New Hampshire Yankee
April 12, 1991

ENCLOSURE 1 TO NYN-91059

RCCA Repositioning Program Engineering Evaluation and Significant Hazards Consideration Evaluation

FIGURE 3.1-1

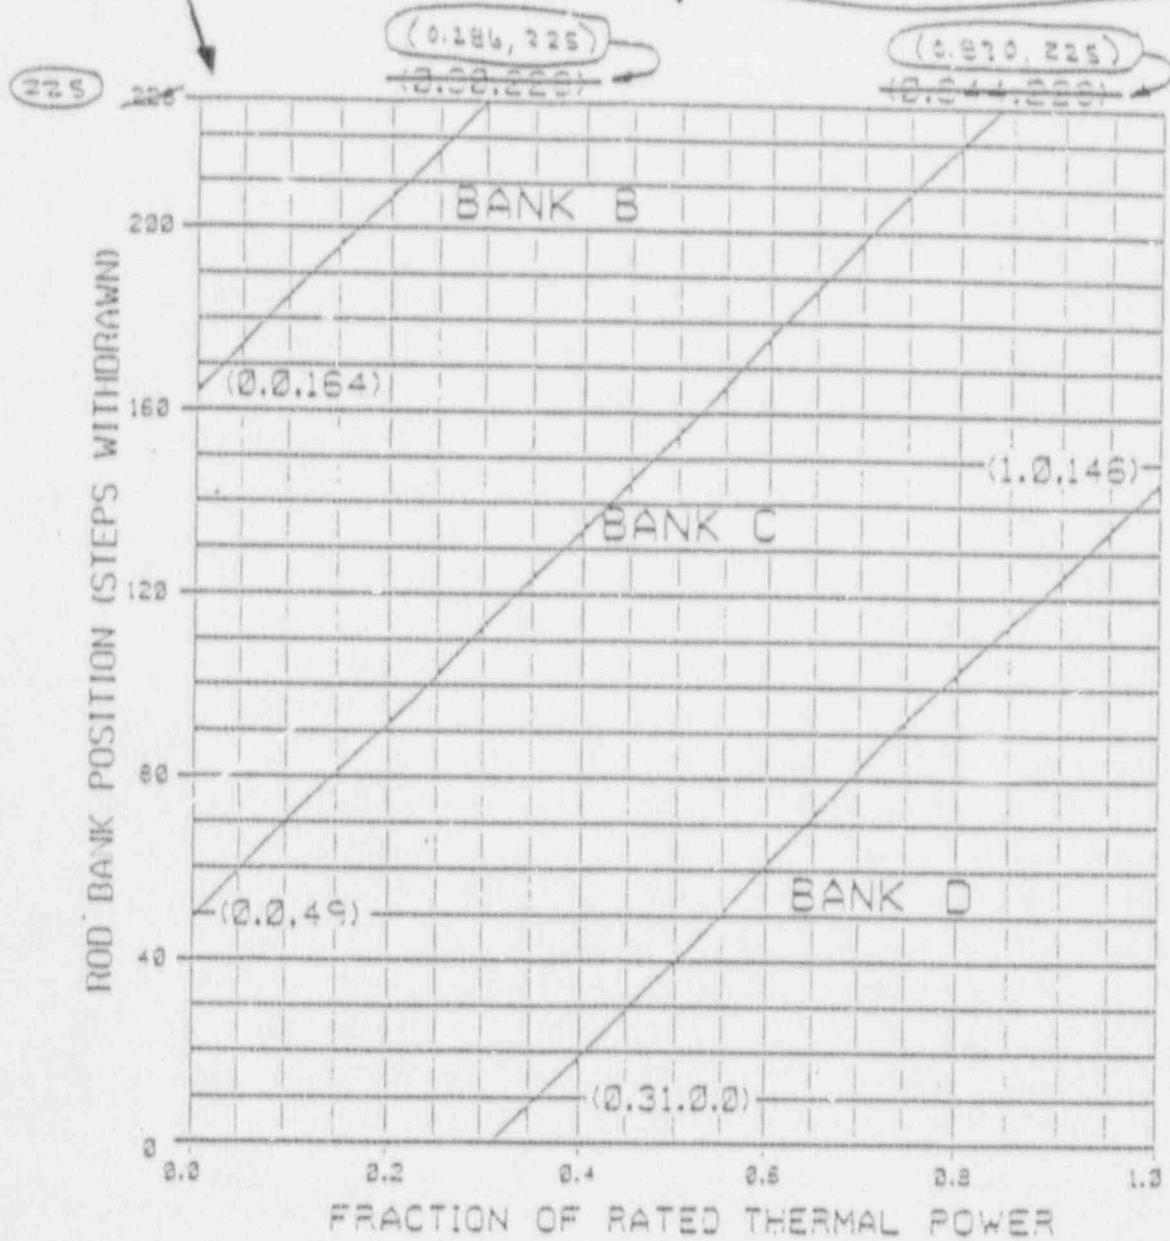
Fully Withdrawn = 225 to mechanical fully withdrawn position, inclusive

BANK A must be fully withdrawn prior to power operation
